UNIVERSITY OF MINNESOTA
HEALTH SCIENCES EXPANSION #68013

POSSIBLE AREAS FOR FOOD SERVICE - UNIT A

University of Minnesota
 Health Sciences Expansion
 TAC Job No. 68013

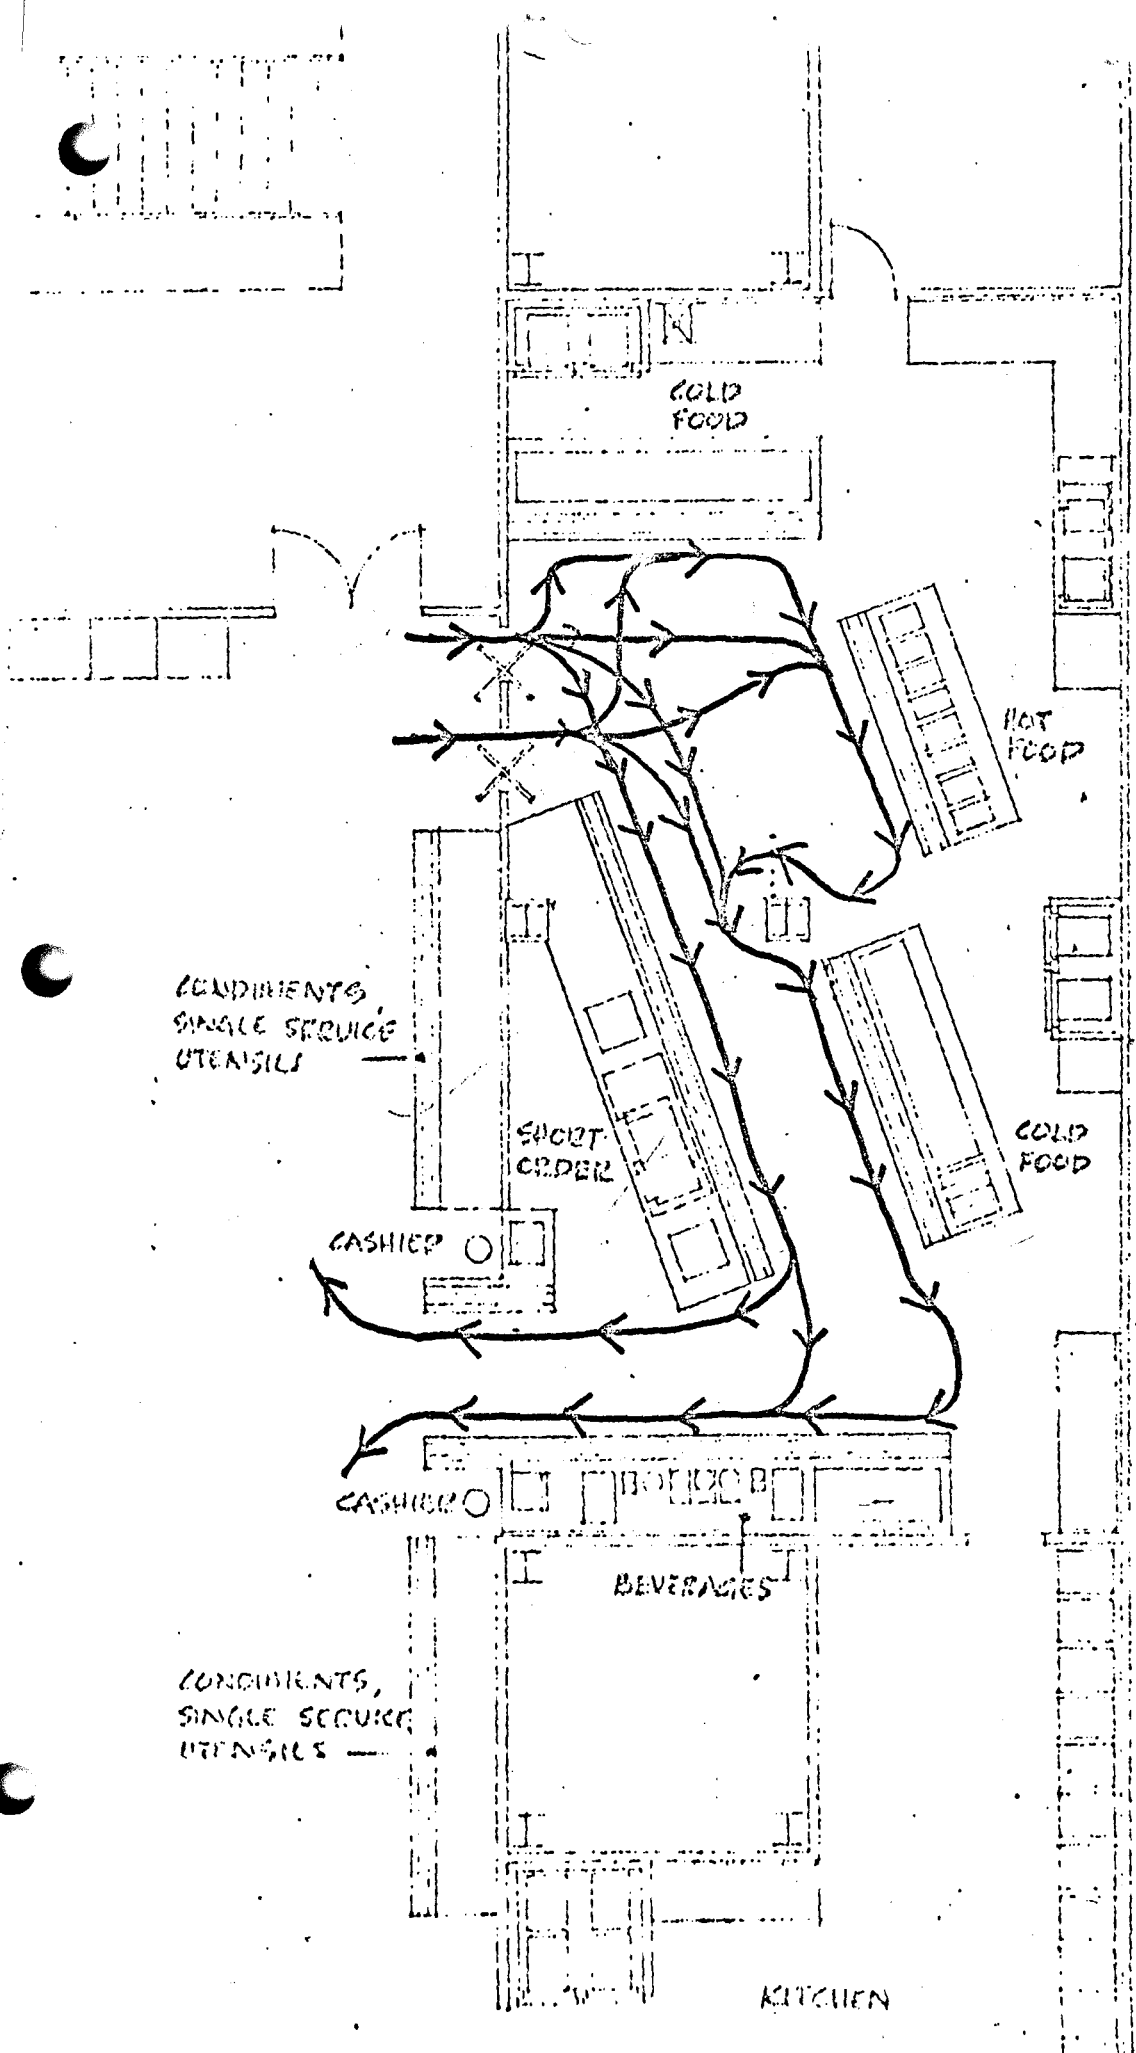
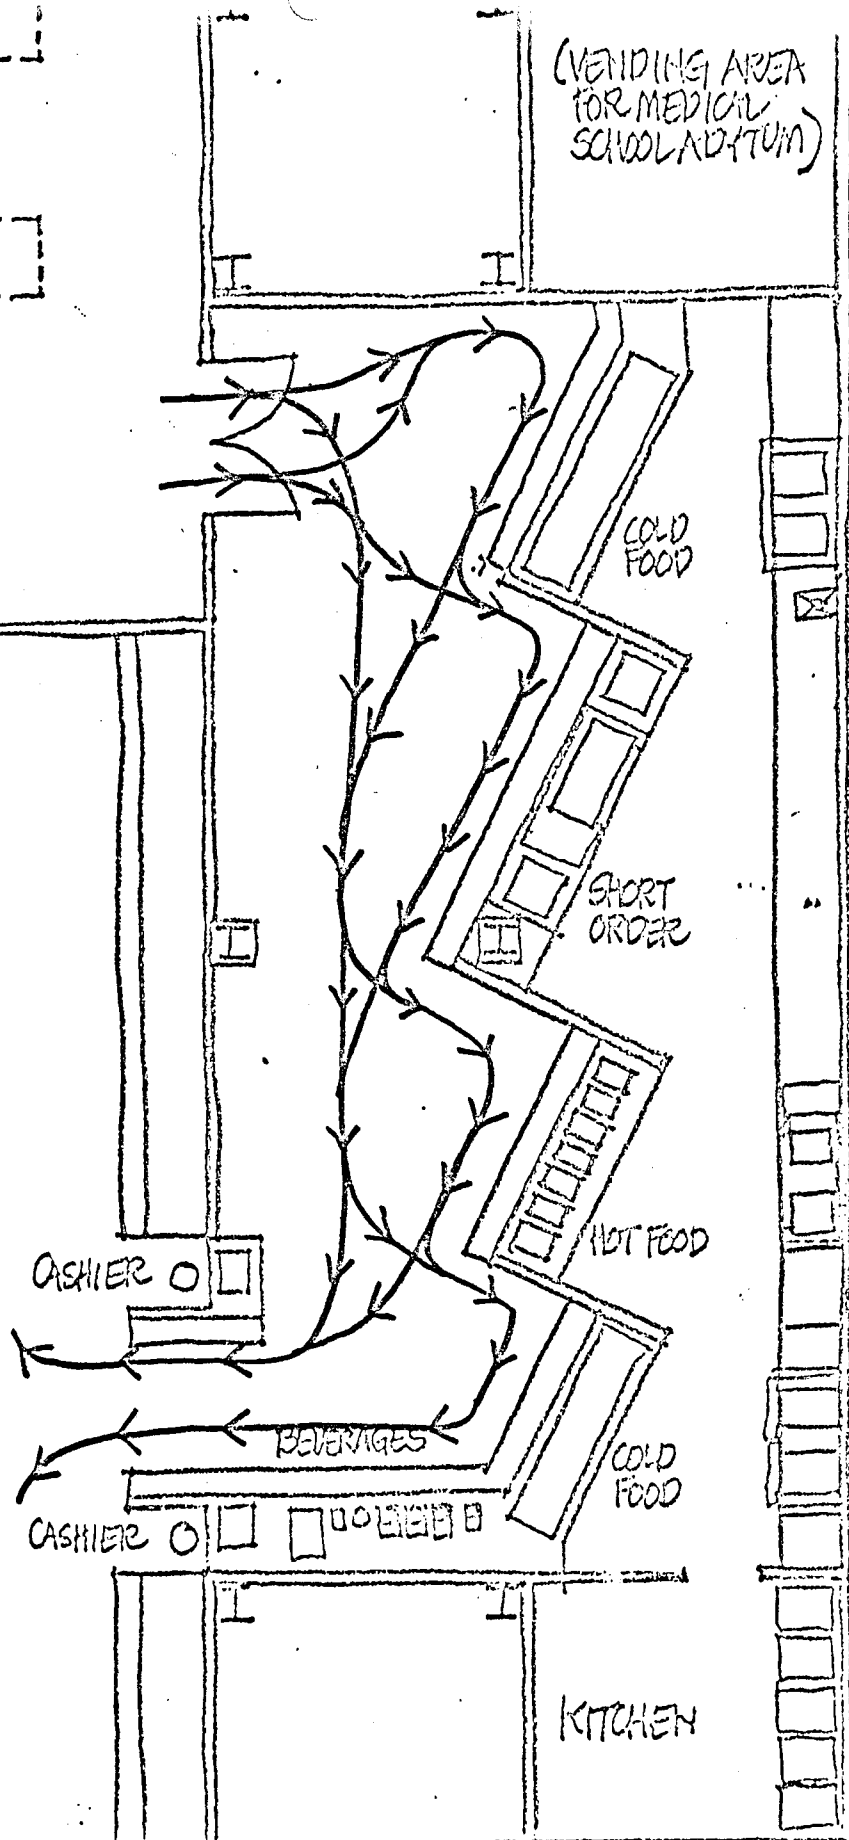
A review of your Unit 'A' drawings has generated questions about the organization of the serving area for the cafeteria on the first floor. The column in the center of the space is an obtrusive element and circulation around it would present a problem.

Regarding the Unit A, Floor 1 cafeteria, you are right, the column in the center of the serving area presents a problem. Please note our enclosed revised sketch. We prefer a random, scramble area type of service to the more conventional type you sketched. We have found the service to be faster and more efficient in the scramble area type.

ENCLOSURE # 2

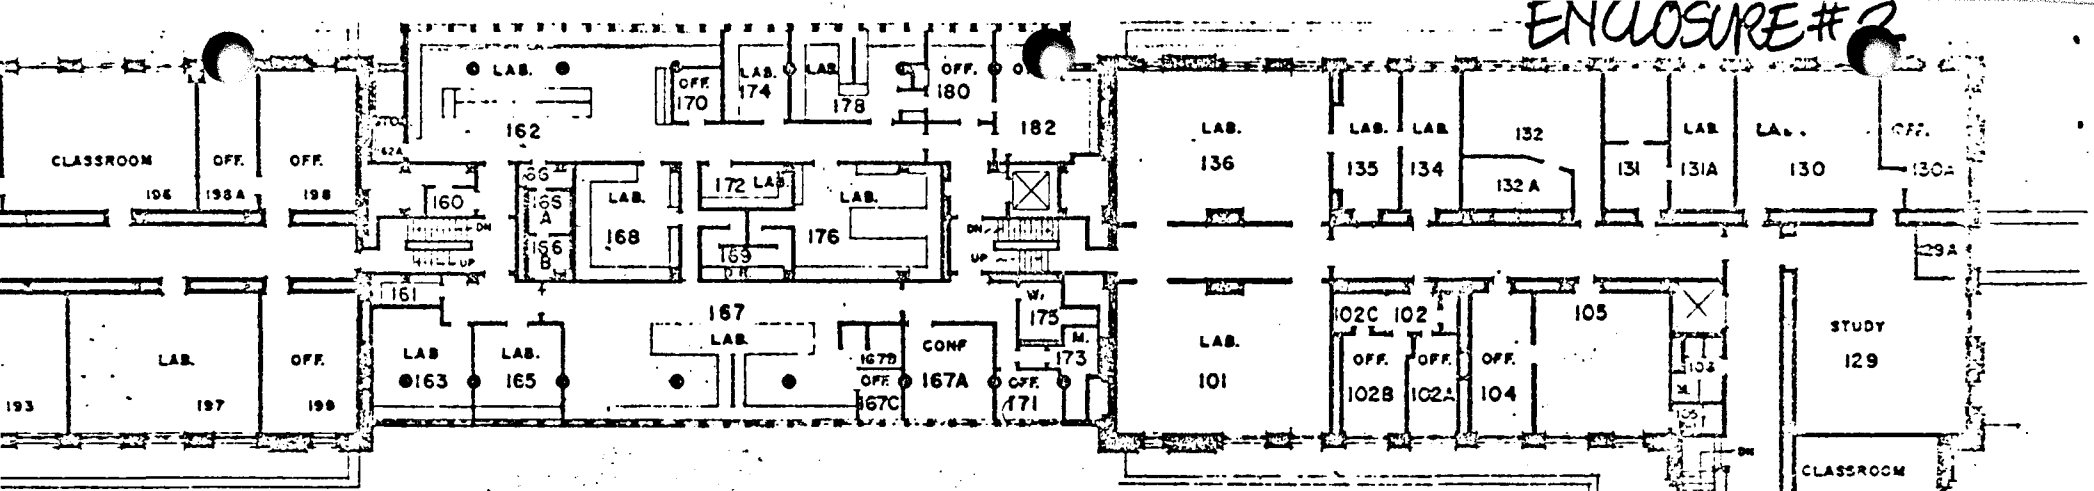
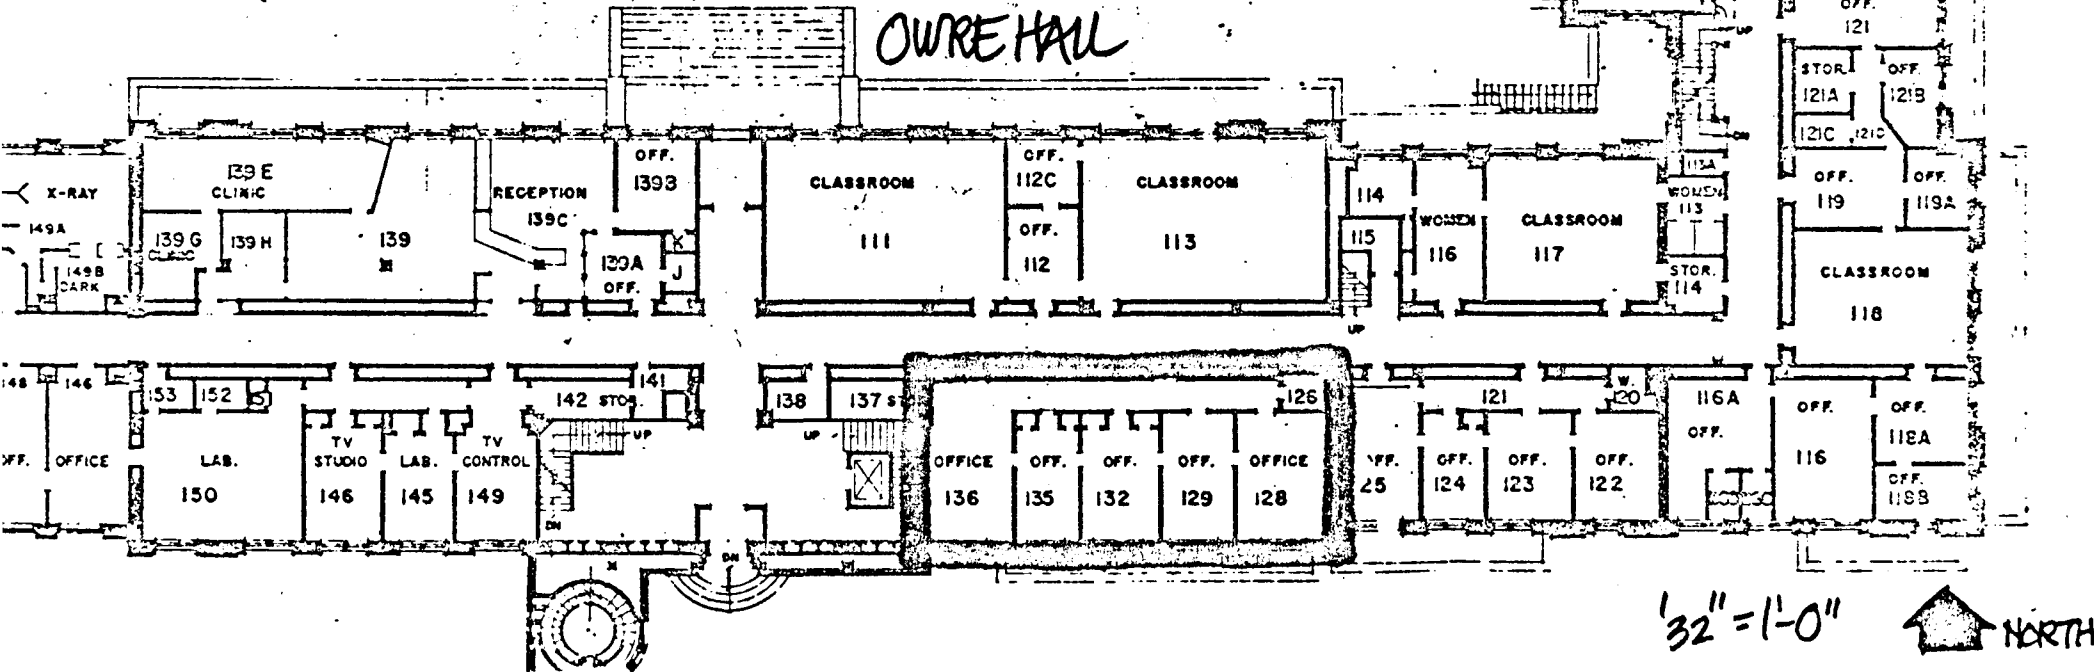
Paragraph 8: The revised schematic plans for Phase 1 include space for food service in Owre Hall first floor rather than Millard. The enclosed as-built drawing (Enclosure #2) indicates the space available for food service totalling 1570 SFN. Please develop a sketch plan for the designated area.
